Our Reference: G30917L-01C

## **607-623 Collins Street, Melbourne – Proposed Mixed Use Development Response to Council Request for Further Information**

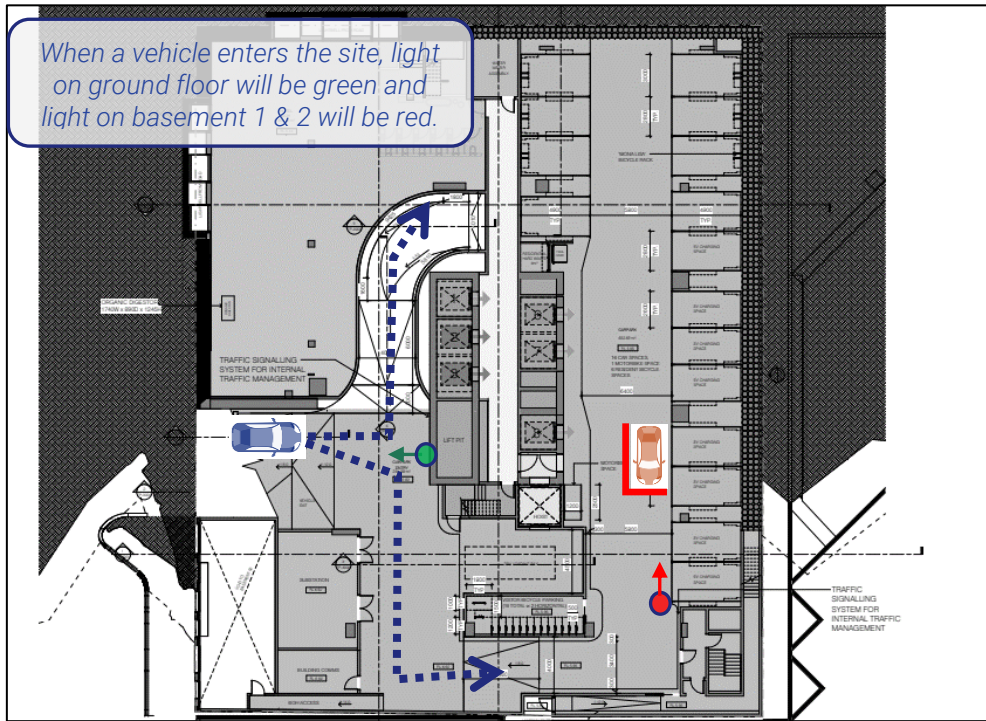
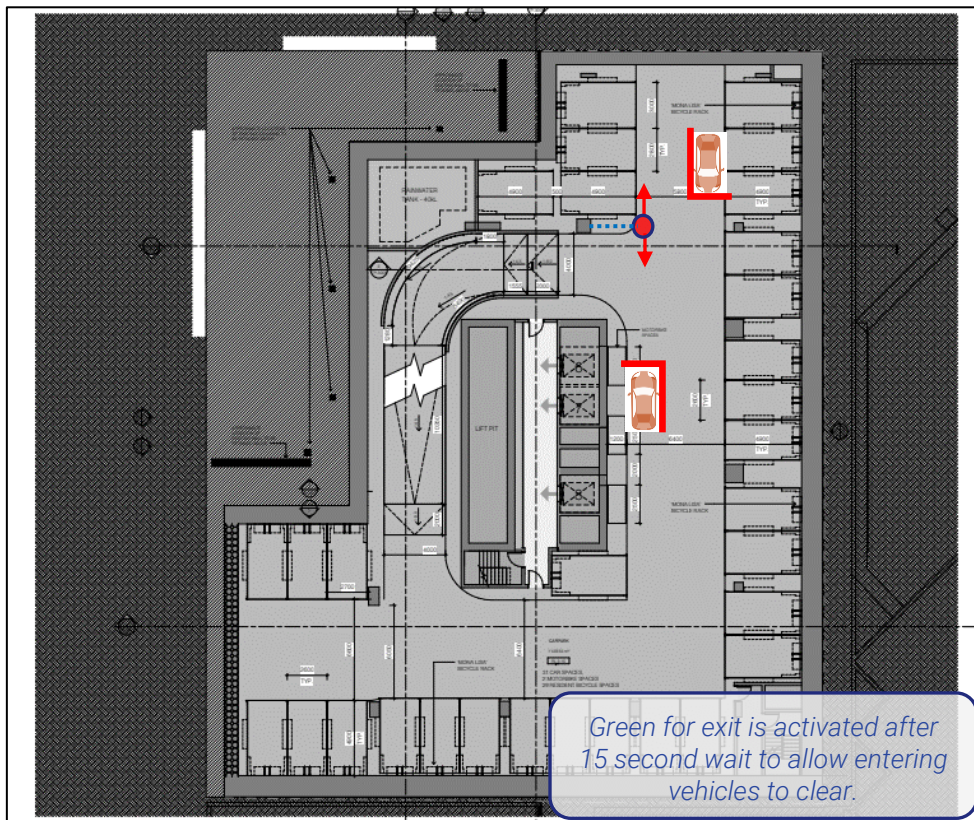
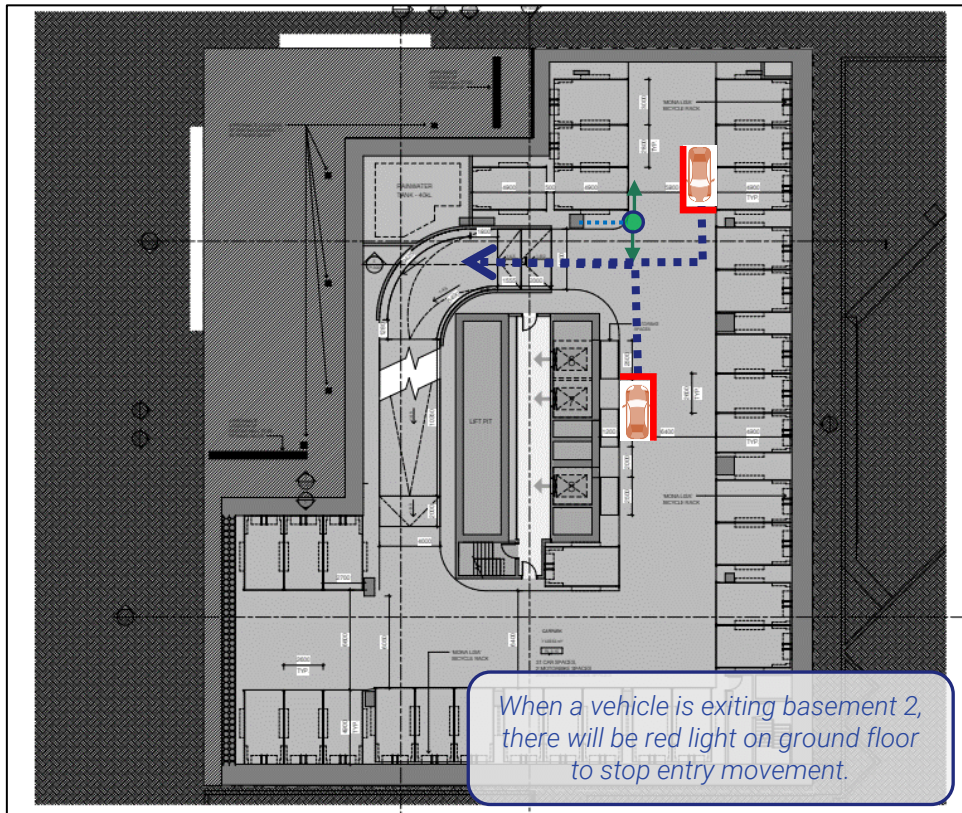
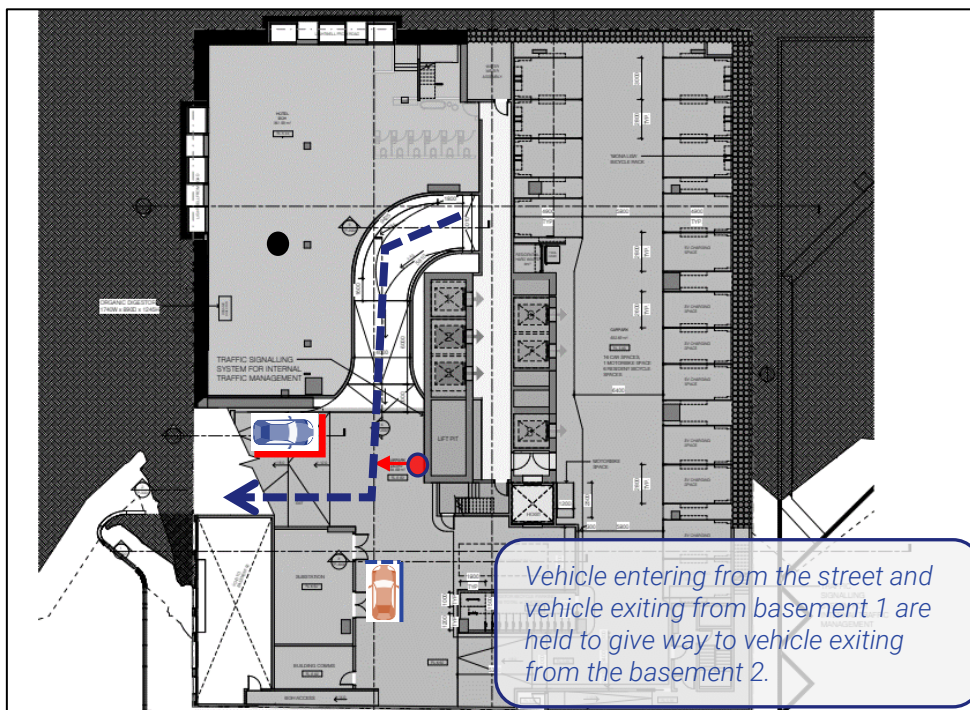
**Council comment** – *The internal ramps can only accommodate one vehicle at a time in each direction. The traffic report states there will be a traffic light system to manage cars on the ramps, however it is not clearly shown where cars will queue. The traffic light management of the access ramp and the internal layout of the car park must ensure that there will not be a queue forming outside the building to access the car park or loading area.*

**Council comment** – More information is needed on internal movements within the car park especially queuing while waiting for their turn on the access ramps to ensure it does not lead to vehicles queuing outside the building blocking pedestrian and vehicle access on the footpath or street.

A traffic signalling system has been prepared below to demonstrate that vehicles entering the site off Spencer Street would have priority over vehicles exiting the site.

The traffic signalling system will be comprised of a red/green signalling system that gives preference to entering vehicles. The system will include:

- A Red/Green Lantern at the Entry (on the lift pit wall).
- Red/Green Lanterns located at key points of in basements 2.
- Supporting line marking and signage supplementing each lantern.
- Infrared or magnetic conduit sensors that are located along the ramp that will be triggered when vehicles go past them on entry or exit. These sensors will be used to help manage the 'logic' of the system.

The system will be programmed for 3 key scenarios, as described below:

**"Default"** being programmed to prioritise entering vehicles with green light shown to the street and red lights shown in basement 1 and 2. In this phase, vehicles will freely enter the site with a green light. When the vehicle turns towards the ramp to basement 2, the entry sensor will be triggered and there will be red light in basement 2 and any exiting vehicles will be required to wait at the nominated hold points for the entering vehicle to pass them (or the sensors).

**"Exit"** Phase being the point at which a vehicle wants to exit the site. In this phase, an exiting vehicle will wait at a holding area, triggering the system to turn 'red' at ground facing entering vehicles and facing exiting vehicles from basement 1 and then subsequently 'green' in basement 2 to allow the exiting vehicle to depart the site. It will revert to default (green at ground) once the vehicles have exited (and triggered the exit sensor). If a vehicle is actively entering when a vehicle wants to exit, the Default Phase will be extended until the entry vehicle passes the relevant sensor points.

**"Internal Passing"** scenario to manage internal passing at basement 2.

In an unlikely event when an entering vehicle is already on the ramp towards basement 1, the vehicle exiting from basement 1 will give way to the entering vehicle but wait within the site on the entry ramp. There will not be any queue external to the site. There will also be a convex mirror provided under the ramp for assisting vehicles leaving basement 1.

The swept paths contained within the traffic report allow for simultaneous movements of two B99 design vehicles at the proposed site access with sufficient opportunities for passing internal to the site. Given the low levels of traffic expected to be generated by the proposal and the priority afforded to entering vehicles, there will be limited chances of a vehicle entering the site having to wait on Spencer Street. Refer to signalling arrangements for more information.
